Subject: REAR SLIDE DOOR LATCH SCREWS CORRODED	Bulletin No: 09-027/07
	Last Issued: 07/13/2007

2006 – 2007 Mazda5 with VINs lower than JM1CR**** ** 141628 (produced before November 1, 2006)

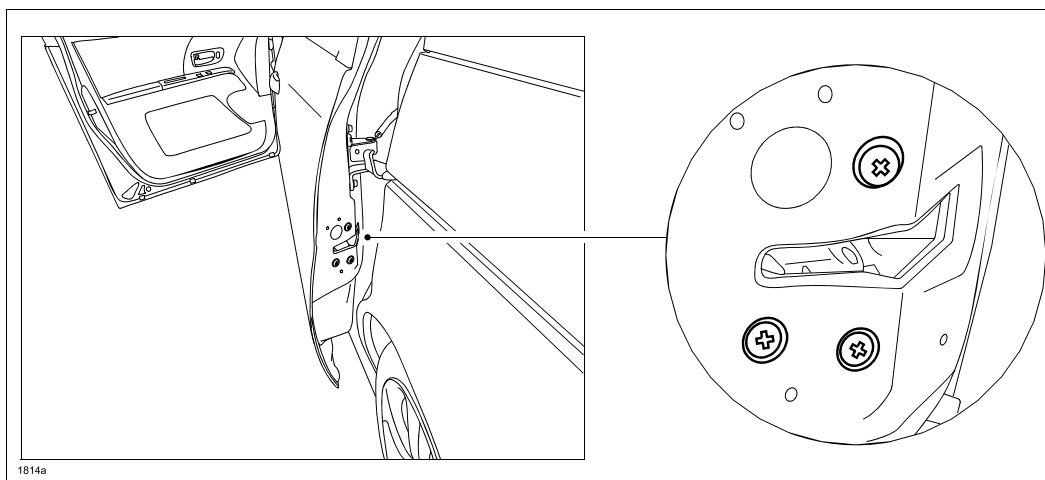
On some vehicles, the screw heads of the rear slide door latch is corroded, which gives a poor quality impression. This is caused by damage to the screw head and the surface treatment by a screwdriver when tightening the screws. To stop this from happening, the film thickness and strength of the surface treatment have been improved.

When you encounter a customer complaint on this concern, replace the screws with modified ones.

Tightening torque: 62 in•lbs (7.0 N•m)

NOTE: Replace the screws one at a time. If you remove all of them, the door latch can fall into the door.
